METROPOLITAN GOVERNMENT OF NASHVILLE AND DAVIDSON COUNTY

STAFF RECOMMENDATION
2701 Oakland Avenue
March 21, 2012

Application: New Construction—addition and accessory structure; Demolition; Setback reduction

District: Belmont-Hillsboro Neighborhood Conservation Zoning Overlay

PLOT PLAN
 AT
2701 OAKLAND AVENUE
 MAP 117-04, PARCEL 166
 D.B. 4549, PG. 876
 18th COUNCILMANIC DISTRICT
 NASHVILLE-DAVIDSON COUNTY-TENNESSEE
 SCALE: 1"=30' DATE: 03-09-12

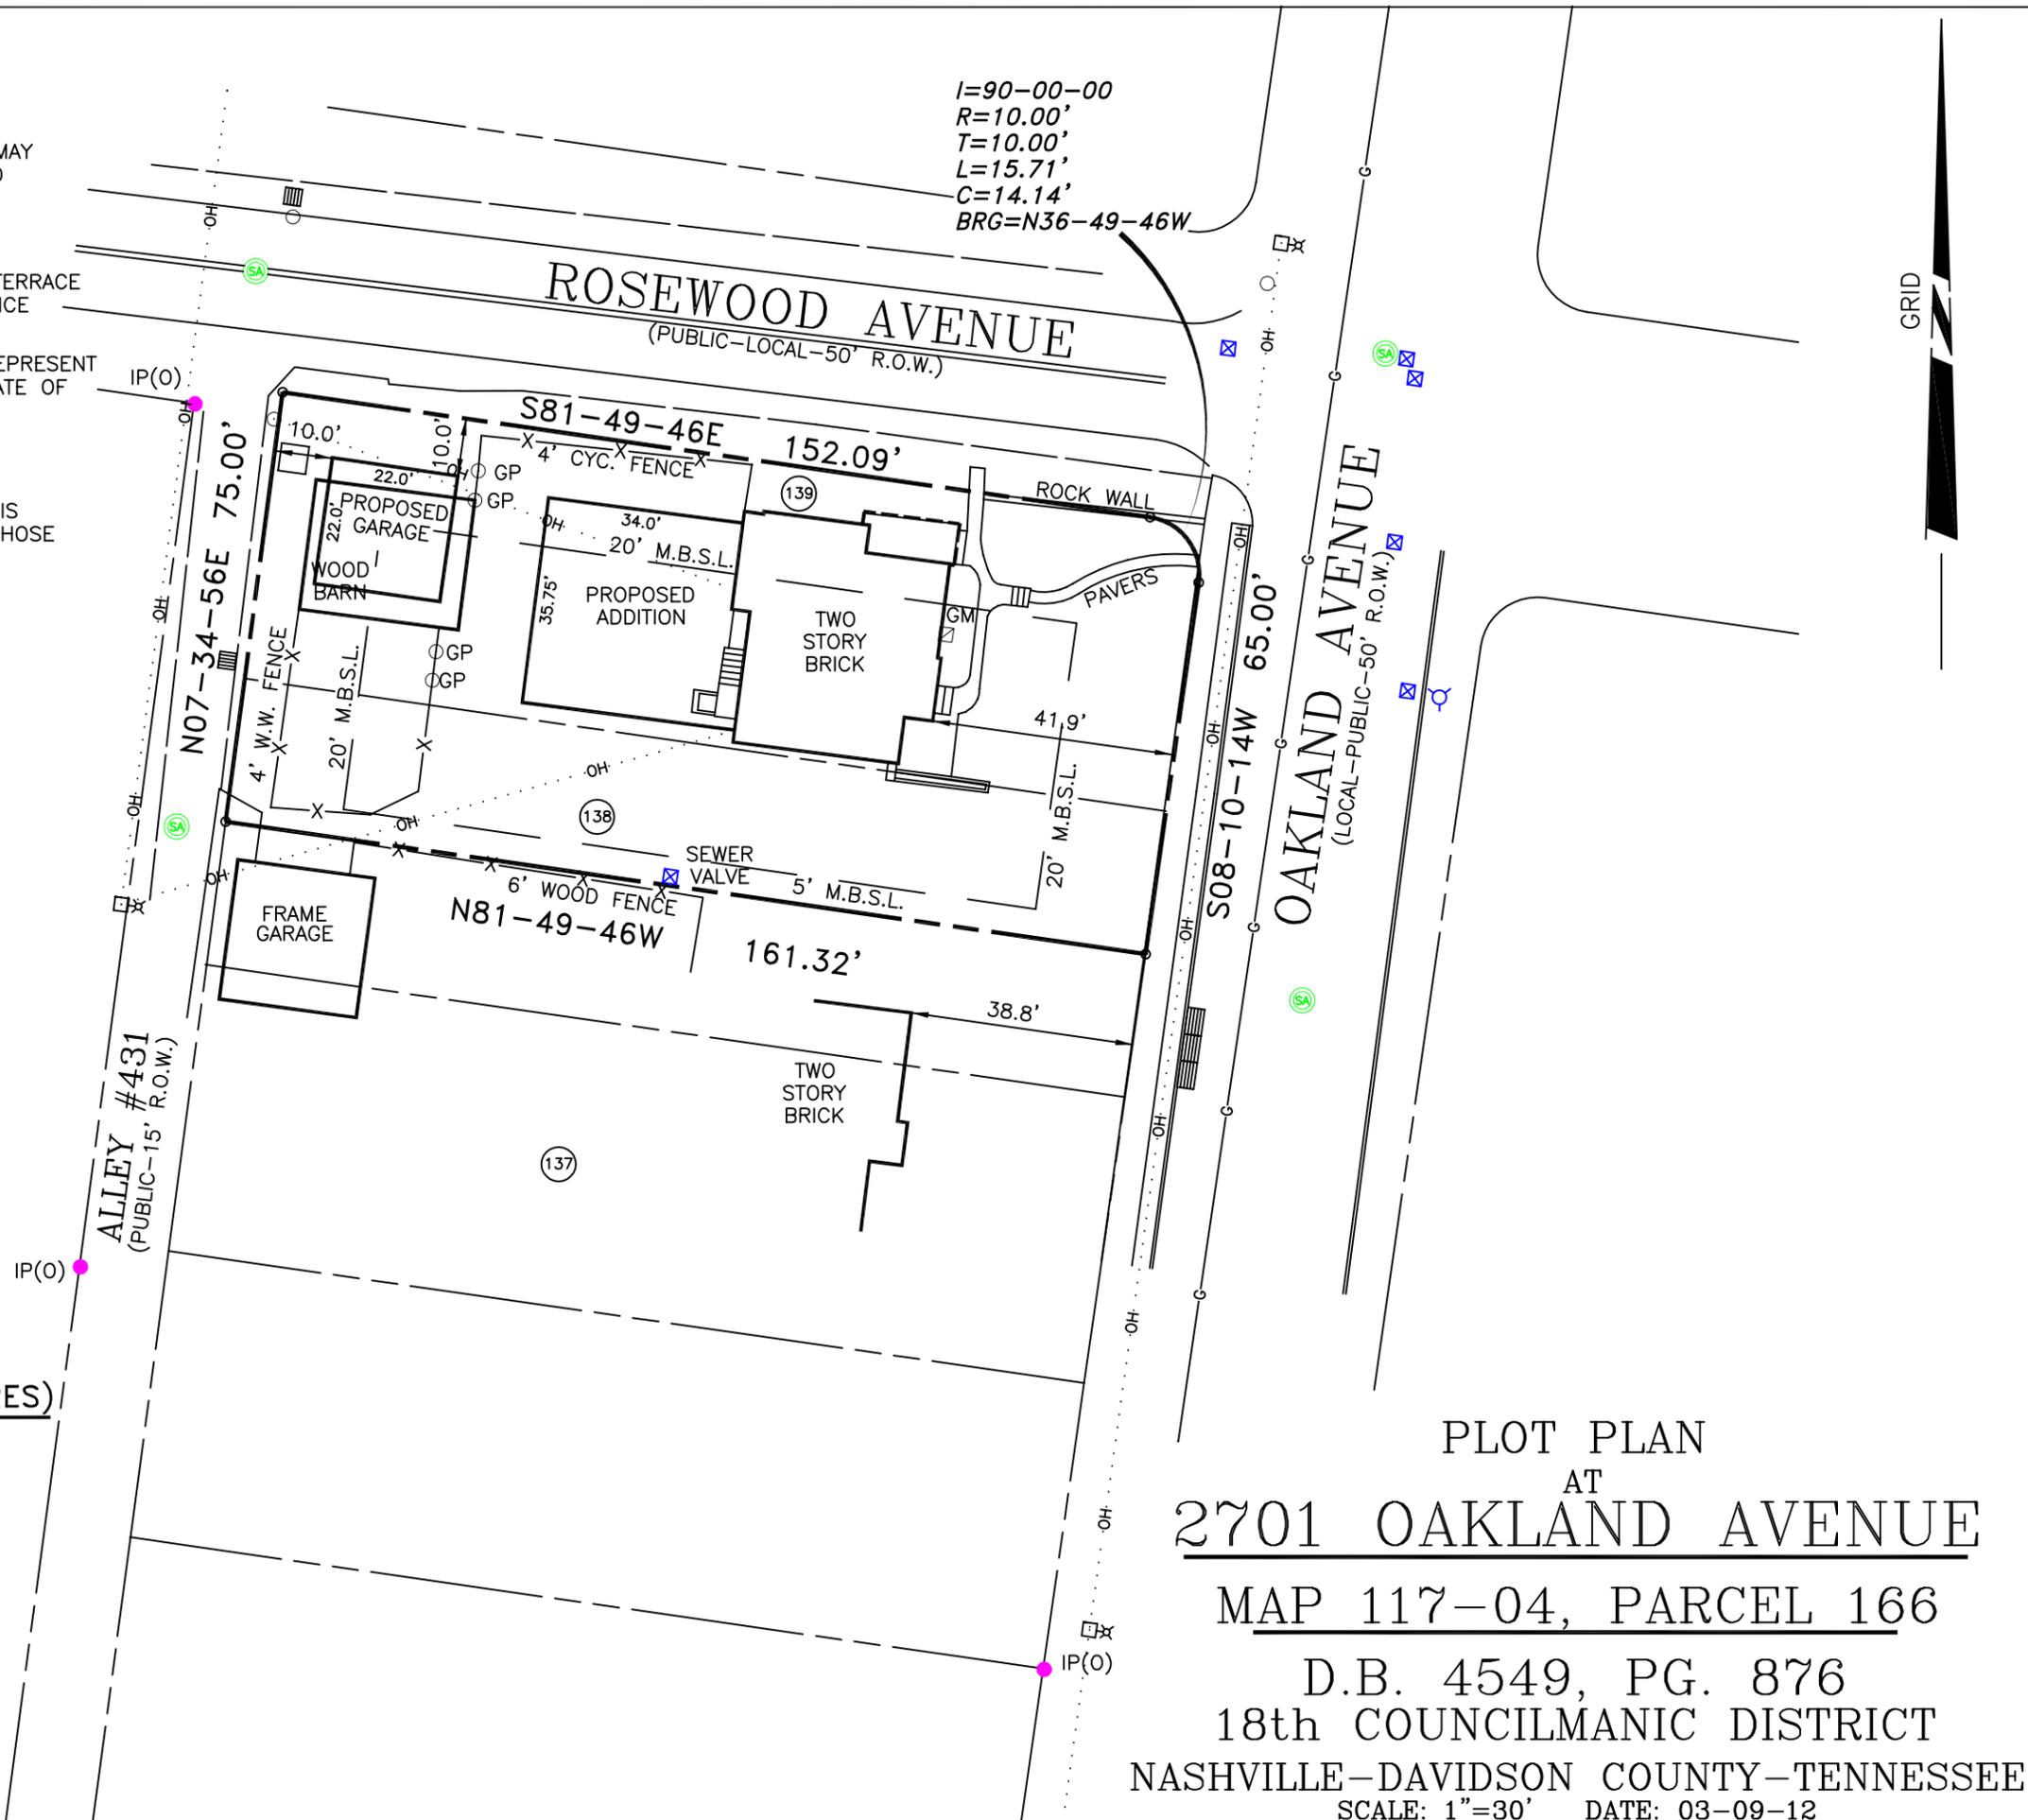
Location and Setback: The proposed addition is located entirely behind the historic house. It is inset approximately two feet from both sidewalls of the historic house, and it meets all base zoning requirements for setbacks.

The proposed accessory structure is located in the rear of the property and is in the approximate location of the existing outbuilding that is to be demolished. Its garage doors face the side street, Rosewood Avenue, which is the same orientation as the existing garage. The proposed accessory structure meets the required setbacks on its front, rear, and left sides. However, it does not meet the required twenty-foot (20') setback on its right (Rosewood Avenue) side. It is proposed to be set ten feet (10') from the right property line. Staff finds the proposed location of the accessory structure to be appropriate in this instance because the existing accessory structure, which is to be demolished, is currently located in a similar location and does not meet the current setback from Rosewood Avenue.

Staff finds the location and setbacks of the proposed addition and accessory structure to meet Section II.B.1.c., II.B.1.i., and II.B.2.a. of the *Belmont-Hillsboro Neighborhood Conservation Zoning Overlay: Handbook and Design Guidelines*.

The design guidelines require that the neighborhood's context of "mass in relation to open spaces" be preserved. With the new addition and accessory structure, the lot's percentage of open space will be approximately seventy-four percent (74%), which is eleven percent (11%) less than the existing site's open space. Even though it will be reduced, the site's open space after the new construction will still be within the range of open spaces on the block, which range from seventy percent to eighty-five percent (70%-85%).
